Cumberland County Subdivision and Land Development Review Report

Municipality: <u>Carlisle</u>	Surveyor/ Engineer: <u>BL</u>	Builder Services Group, Owner/ Inc TDBA Kenneth Developer: <u>Homes</u>
Plat Title: <u>Northside Village Lots 4 & 6 IAC Site</u>		
Plat Status: <u>Preliminary/Final</u>	Plat Type: <u>Land Development</u>	
# of New Lots: _____	# of New Dwelling Units: <u>50</u>	New Acreage Subdivided/Developed: <u>4.15</u>
		Total Tract Acreage: <u>4.15</u>
Zoning District: <u>UM Urban Mixed Use</u>	Proposed Land Use: <u>Residential</u>	
Date Received: <u>7/23/2020</u>	County Review: <u>7/28/2020</u>	Reviewed by: <u>SH</u> Checked by: _____

FINAL LAND DEVELOPMENT PLAN NORTHSIDE VILLAGE

LOTS 4 & 6 OF FORMER IAC SITE

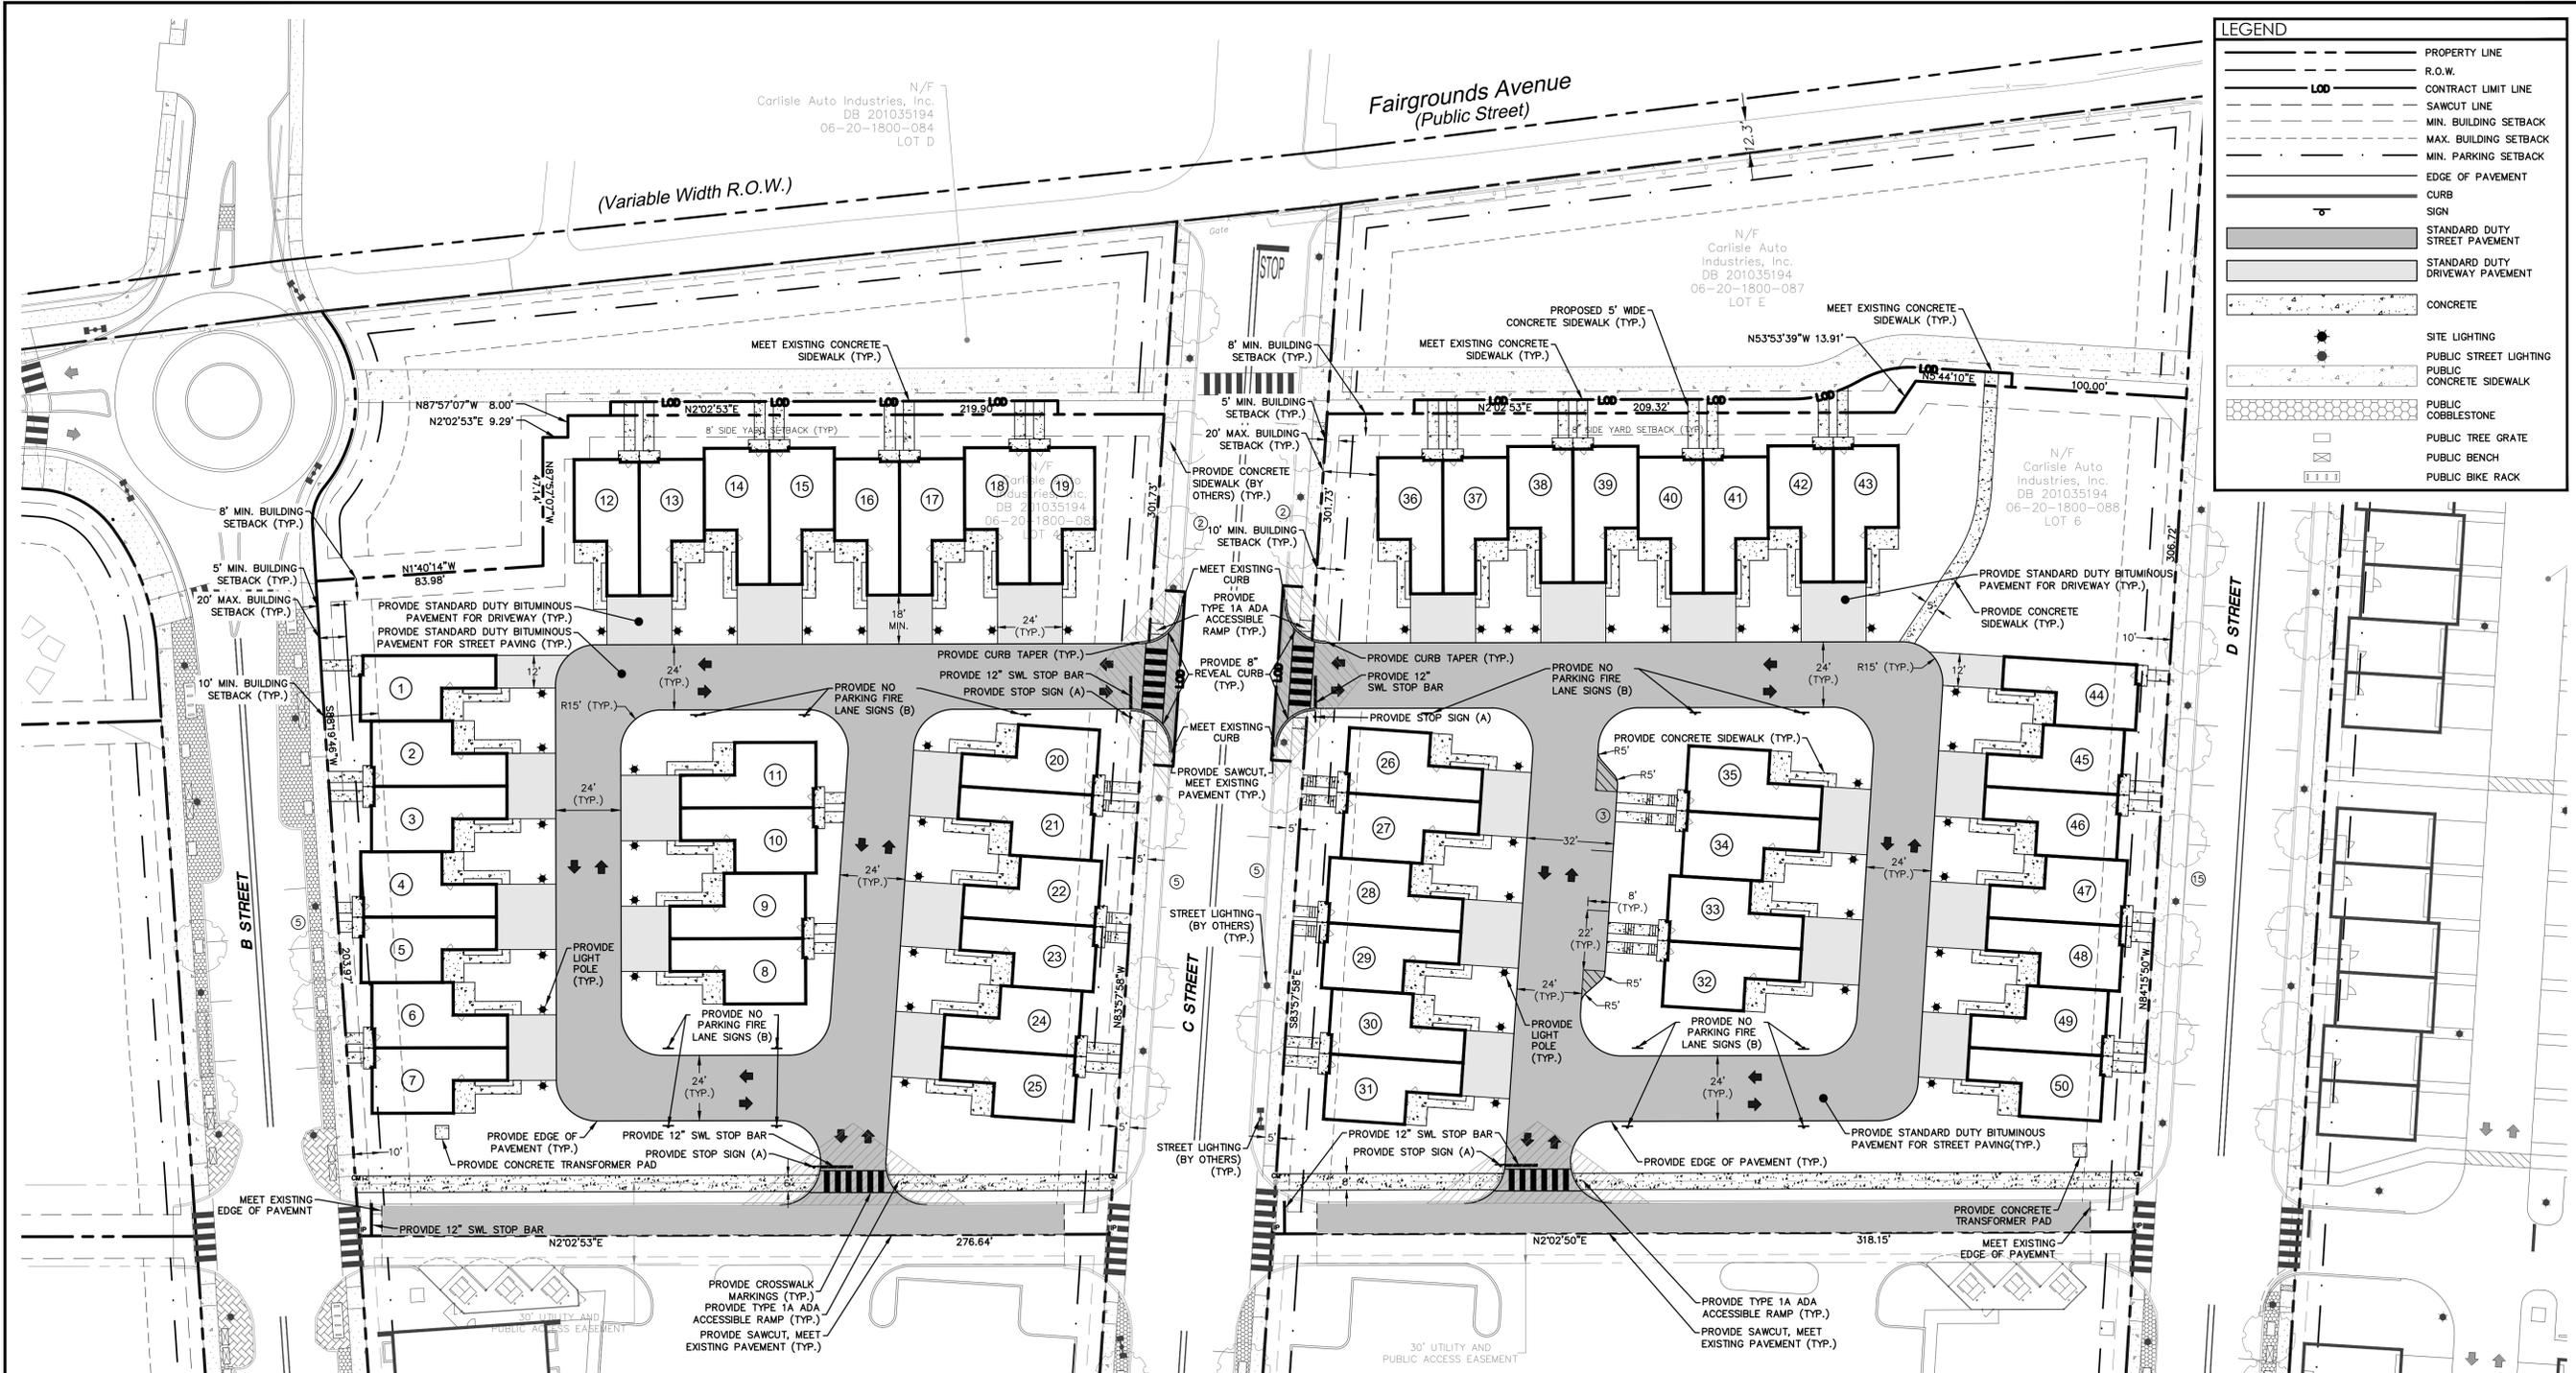
2. If applicable, mailbox clusters should be indicated on the plan (Zoning 255-199.A.17.M).
3. Site Plan Note #41 indicates that each townhouse will have individual trash collection service. The Borough may want to determine if common trash receptacles are required (Zoning 255-199.A.17.N). Further, a recycling bin should be provided for the residents.

4. A minimum of 8% of the total land area should be dedicated to and suitable for recreation (Zoning 255-199.A.17.Q.1).
5. The parking provided for each unit appears to include one garage space and one external parking space which may create conflicts. The parking area should be designed to allow vehicles to proceed to and from the parking space without requiring the moving of any other vehicle (Zoning 255-210.E).

12. Will the proposed street located east of lots 4 and 6 will be dedicated to the Borough?
 - a. If yes, a street name should be approved by the Borough and the county MSAG Coordinator (911 Operations).

- b. If no, it appears that the street will be utilized by lots 5 & 7 as well as thru traffic. The plan should include joint use and maintenance responsibilities.

13. The proposed street lighting and concrete sidewalk on C Street indicates that it will be provided by others. Will the Borough be responsible for providing these features?
